# Xiamen Hanin Co.,Ltd.

## FCC Class II Permissive Change Application Letter

Product name : Portable Label Printer

FCC ID: 2AUTE-2DT23JR

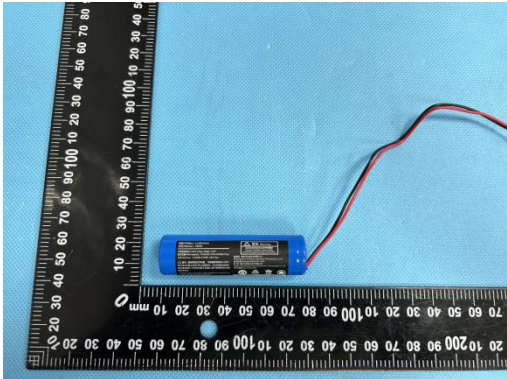
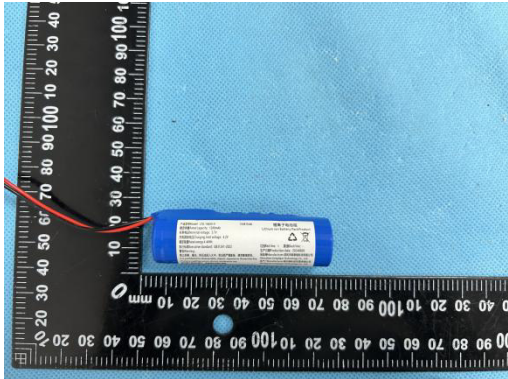
Change Contents: update the components on Product as below (The part to be modified is battery.):

Location	Old of FCC ID: 2AUTE-2DT23JR	New of FCC ID: 2AUTE-2DT23JR
Battery		
	<b>Li-ion Battery</b> <b>Model: 18650 3.7V, 1500mAh</b> <b>Huizhou superstar Technology Co,Ltd</b>	<b>Lithium ion Battery PackProduct</b> <b>Model: LTG-18650-9 3.7V, 1200mAh</b> <b>Shenzhen Longtiger Technology Co, Ltd.</b>
Modifications that do not change the fundamental RF characteristics and that do not degrade the unwanted emissions of the certified product, please refer to test report for more details; Modifications that do not change physical characteristics significantly. We attach new photographs to identify the modified product.
